**Re: Third Submission Review – The Aurora Highlands North – Area C - Site Plan**  
Application Number: DA-2062-44  
Case Numbers: 2023-4023-00

## *Third Submission Review*

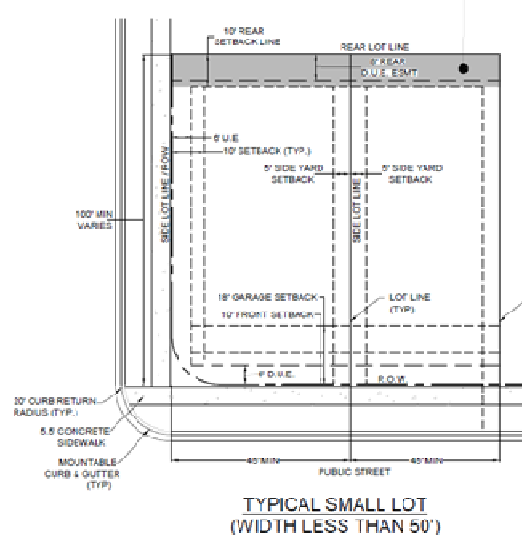
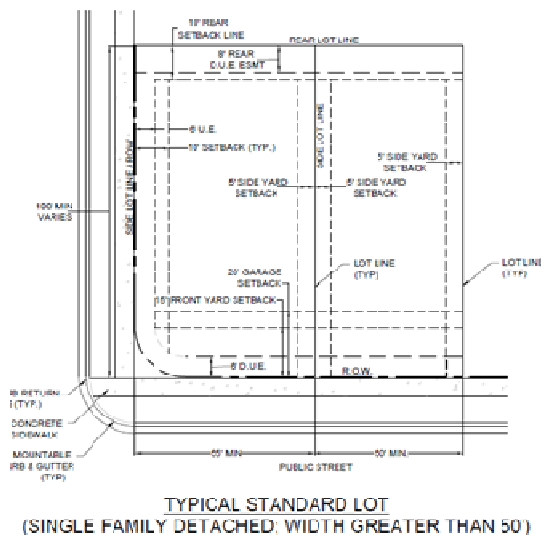
Public Service Company of Colorado's (PSCo) Right of Way & Permits Referral Desk has reviewed the 3<sup>rd</sup> referral documentation for **The Aurora Highlands North - Area C**. While the comment response says "acknowledged" regarding PSCo's second round letter, it does not appear that "DUE" was expanded to 9- or 10-feet on the plan:

Additionally, at the lot level it appears that the easements not are labeled as "D.U.E" but as "U.E" on the snip below:
